Project	IEEE 802.16 Broadband Wireless Access Working Group < http://ieee802.org/16 >	
Title	Framework for Enabling Closed-loop MIMO for OFDMA	
Date Submitted	2005-01-25	
Source(s)	<p>Wonil Roh, JeongTae Oh, Chan-Byoung Chae, Kyunbyoung Ko, Hongsil Jeong, Sung-Ryul Yun, Seungjoo Maeng, Jaeho Jeon, Jaeyeol Kim, Soonyoung Yoon</p> <p>Samsung Electronics Co., Ltd.</p> <p>Erik Lindskog, Harold Artes, Djordje Tujkovic, Kamlesh Rath, Andreas Bergkvist, V. Shashidhar, B. Sundar Rajan, Rahul Vaze, Bob Lorenz, Babu Mandava, A. Paulraj, Aditya Agrawal</p> <p>Beceem Communications, Inc.</p> <p>Young-Ho Jung, Seung Hoon Nam , Jaehak Chung, Yungsoo Kim, Sung-Jin Kim, Hojin Kim</p> <p>Samsung Advanced Institute of Technology</p> <p>Wen Tong, Peiying Zhu, Ming Jia, Dongsheng Yu, Hua Xu, Jianglei Ma ,Mo-Han Fong, Hang Zhang, Brian Johnson</p> <p>Nortel Networks</p> <p>Qinghua Li, Xintian Eddie Lin, Sumeet Sandhu, Shilpa Talwar, Randall Schwartz, Alexey Davydov, Uri Perlmutter, Nageen Himayat, Minnie Ho</p> <p>Intel Corporation</p> <p>Bin-Chul Ihm, Yongseok Jin, Jinyoung Chun, Kyuhyuk Chung</p> <p>LG Electronics</p> <p>Kevin Baum, Mark Cudak, Tim Thomas, Fred Vook Xiangyang (Jeff) Zhuang</p> <p>Mot

Figure 231c - Mapping of MIMO coefficients for quantized precoding weight for enhanced fast MIMO feedback payload bits

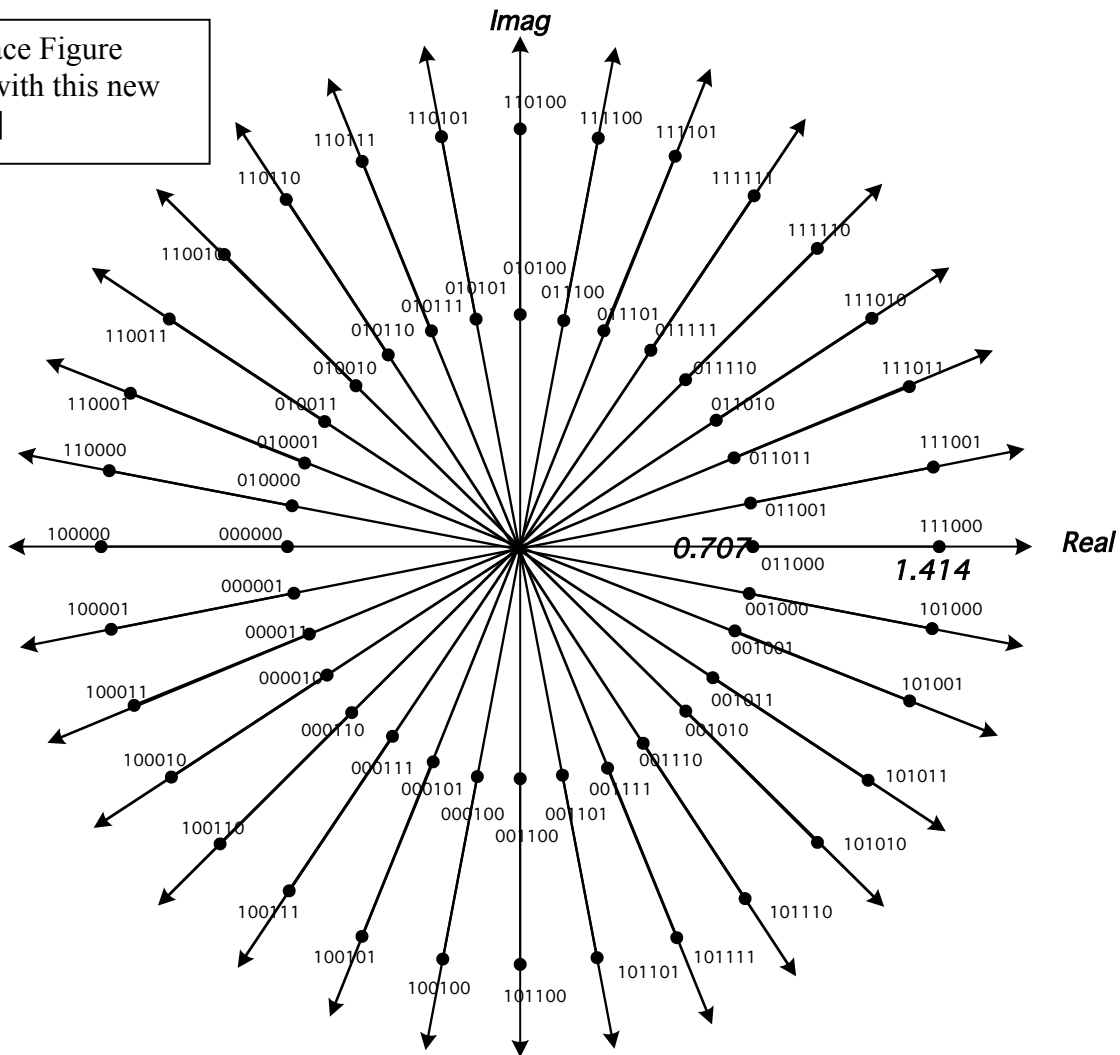
When the FAST_FEEDBACK subheader Feedback Type field is '01' or '10', or the CQI Feedback Type field in the MIMO Compact DL-MAP IE() (see 6.3.2.3.43.6.7) is 011, or the CQI Feedback Type field in CQICH_Enhanced_Alloc_IE() (see 8.4.5.4.15) is 011, the MSS shall report the MIMO coefficient the BS should use for best DL reception. The mapping for the complex weights is shown in Figure 231c, and the SS shall construct the 6 CQI bits with 0 as the MSB and the mapped code as the remaining LSBs. For this type of feedback, if N is the number of BS transmit antennas, then $(N-1)$ CQICH shall be allocated to the SS and SS shall report the desired antenna weights of antenna 1 through $N-1$ based on antenna 0.

[Replace Figure 231c with this new figure]
